Office Action Summary

10/603,115

DING ET AL.

DETAILED ACTION

FIG. 4

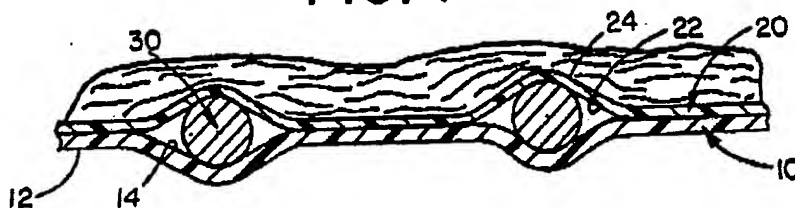
2. Applicant's arguments filed 5/4/2009 have been fully considered but they are not persuasive. Applicants have amended the claims to recite that at least a portion of the undercoat covers at least a portion of the outer surface of the open lattice tubular sidewall, and the topcoat is at least partially covering the portion of the undercoat that covers the outer surface of the open lattice tubular sidewall.
3. Applicant thus argues that the sandwiched ring prosthesis of Lee (reproduced below) does not include a topcoat at least partially covering the portion of the undercoat that covers the outer surface of the open lattice tubular sidewall.

4. Examiner disagrees. As mentioned in the previous rejection, the language "covers" does not necessitate that one layer is directly atop another layer (like a roof still covers the first floor of a multi-story house).

5. Regardless, in order to fully address Applicant's claim amendments it is important to note that the only difference between the claimed device and Lee is the arrangement of the layers.
